Access Compliance Report

Public Rights-of-Way

Intersection ID: 12548	Main Street: W MARTIN LUTHER KING JR BV	Access Street: S TRYON ST	Location: N
ADA ID: 6E23E0D08422	Ramp Type: PerpDiag	Initial Pass/Fail: Fail	Overall Compliance: No
Codes/Mitigation Info/Possible Solution		Field Measurements/Component Compliance	
Severity Score: 13.75

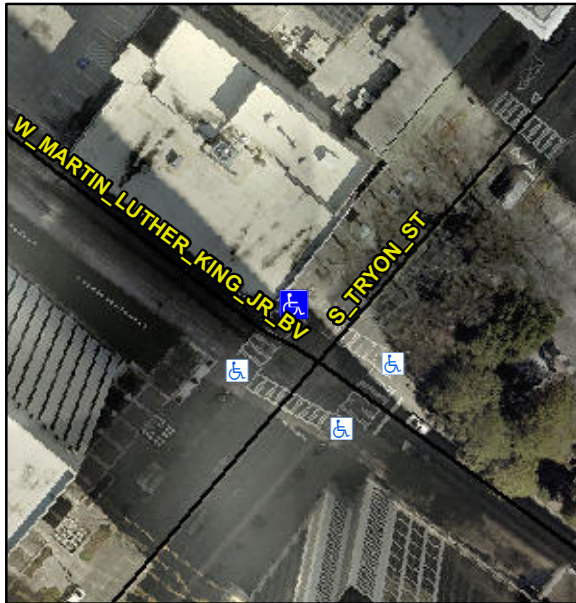
Not Found, R304.2.2, R304.5.3

Compliance	Description	Data	Compliance	Description	Data
N/A	Ramp Length (in)	67.0	No	Ramp Slope (%)	9.4
Yes	Ramp Width (in)	67.0	No	Ramp XSlope (%)	3.2
N/A	Flare Type LT	N/A	N/A	Flare Type RT	N/A
N/A	Flare Slope LT (%)	N/A	N/A	Flare Slope RT (%)	N/A
N/A	Flare Traversable LT?	N/A	N/A	Flare Traversable RT?	N/A
N/A	Landing Length (in)	N/A	N/A	DWS Provided?	N/A
N/A	Landing Width (in)	N/A	N/A	DWS Contrast?	N/A
N/A	Landing Slope (%)	N/A	N/A	DWS Length (in)	N/A
N/A	Landing X Slope (%)	N/A	N/A	DWS Full Width?	N/A
N/A	Landing Curb? (Y/N)	N/A	N/A	DWS Offset (in)	N/A
N/A	Shared Landing?	N/A			
N/A	Gutter Ponding?	N/A	N/A	Gutter Slope (%)	N/A
N/A	Gutter Lip Ht (in)	N/A	N/A	Gutter X Slope (%)	N/A
N/A	Painted X Walk1?	Yes	N/A	Painted X Walk2?	Yes
	X Walk 1 Direction	To SW		X Walk 2 Direction	To SE
N/A	X Walk 1 Width (in)	168.0	N/A	X Walk 2 Width (in)	108.0
	X Walk 1 Slope (%)	0.8		X Walk 2 Slope (%)	1.0
	X Walk 1 X Slope (%)	1.4		X Walk 2 X Slope (%)	0.5

Remove & Replace Curb Ramp With Two New Directional Ramps or Equivalent.
